Local Planning Panel

Address: 410 Pitt Street, Haymarket

(two) Applications to LPP: D/2015/661/D & D/2020/1387/C

Proposal

north & west elevations (Miramar Building & Pitt Street)

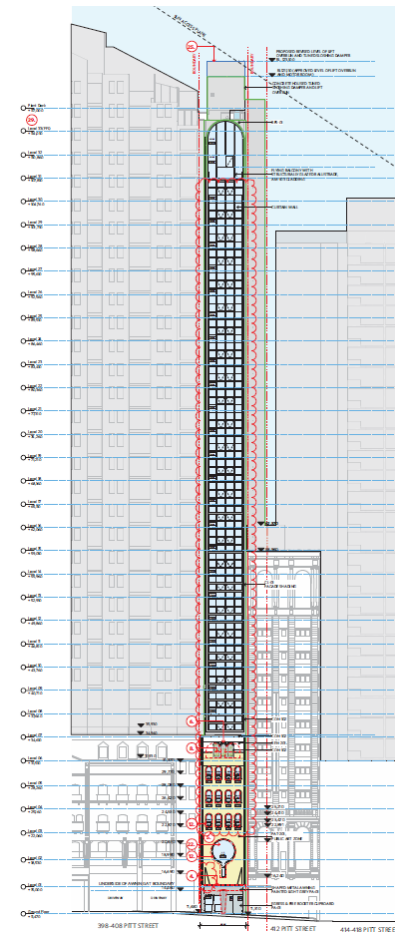
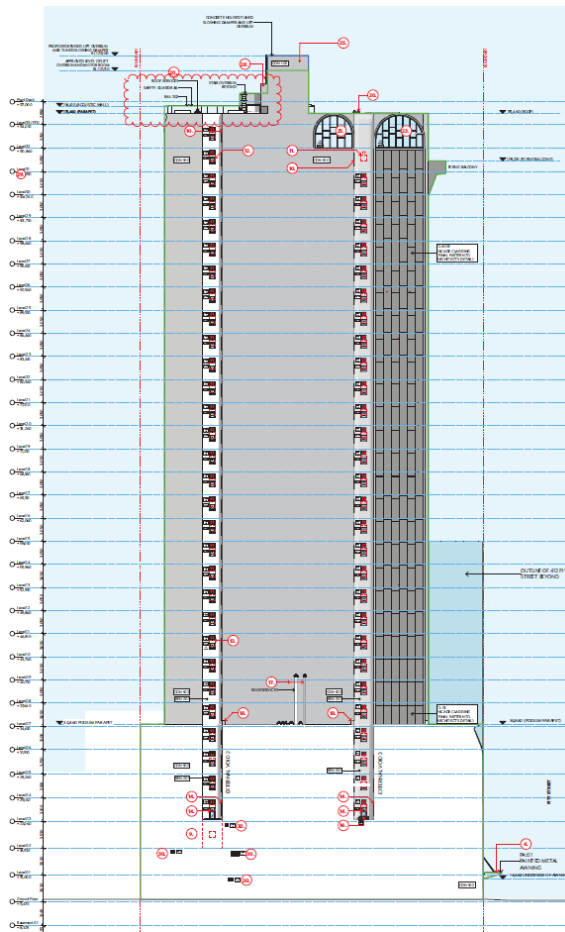
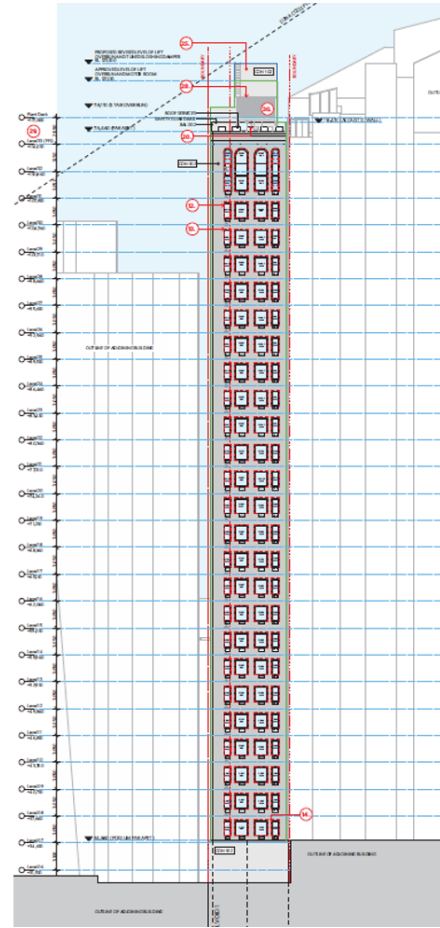
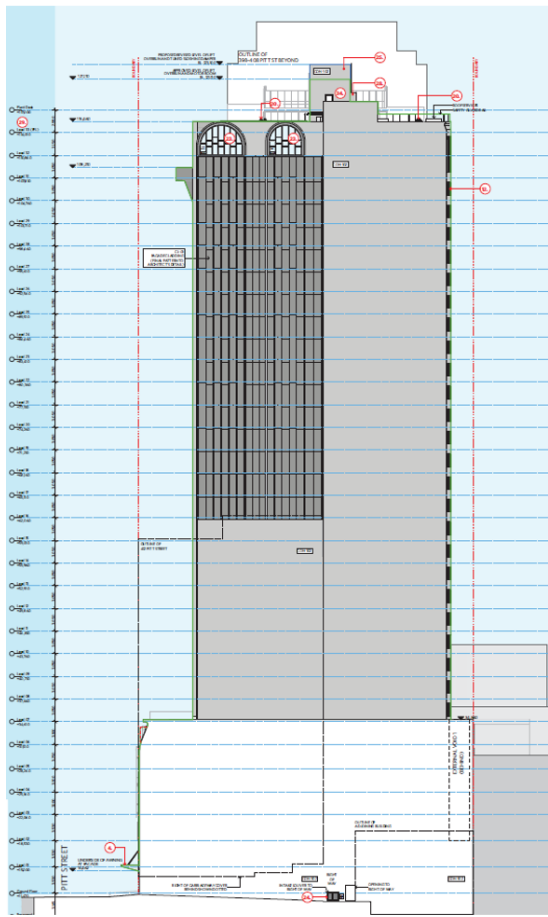
- remove note on north elevation plan, still describing 'acoustic wall'
- operable windows to be provided on east elevation, as per approved Mod A plans (D/2020/1387/A)
- details of privacy treatments - east-facing hotel rooms are 17m from west-facing windows residential apartments (414-418 Pitt Street)
- maintain high quality materials & visual privacy
 - Material 'RFS:01' to remain previously approved zinc roof not concrete roof
 - Material 'GL:02': Obscure Glass to be provided to all corridor windows facing north

view loss

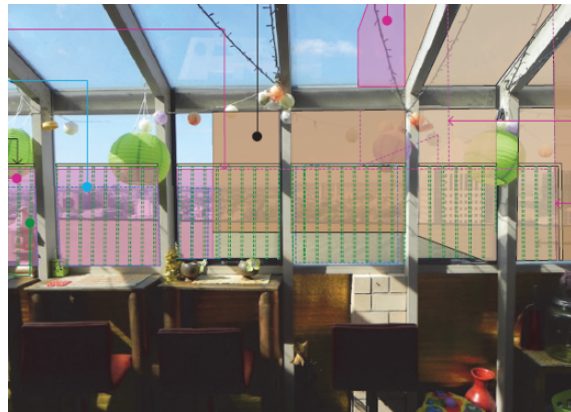
- Council RFI letter 4 July 2025:
additional view loss unacceptable
- amended plans received 11 July:
acoustic screen removed, plant
lowered
- improved outcome for owner of
penthouse apartment in Miramar
Building (398-408 Pitt Street), views
across site maintained

view loss

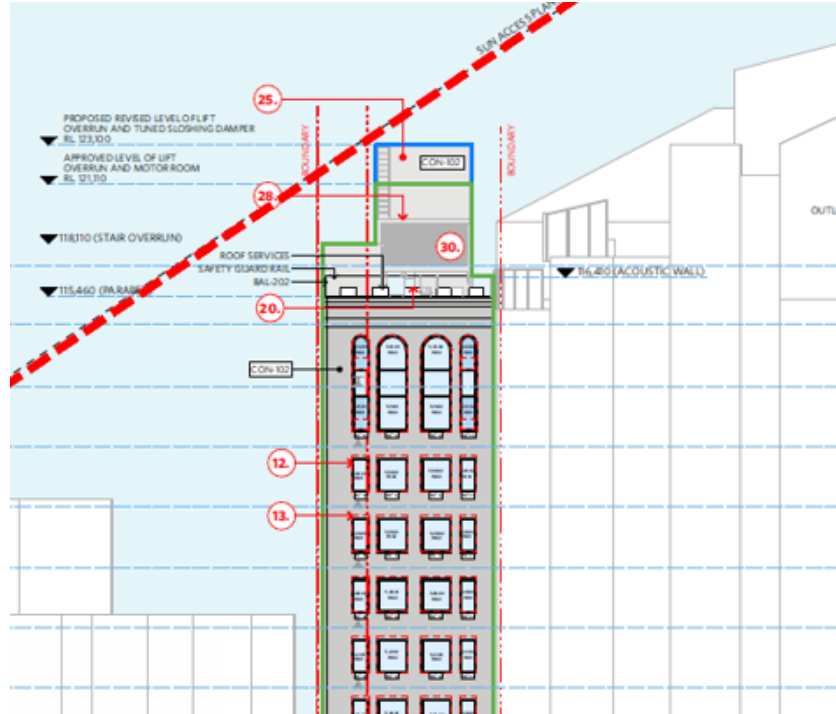
- improved outcome for penthouse apartment in Miramar Building (398-408 Pitt Street)
- views across site maintained as per Court approval
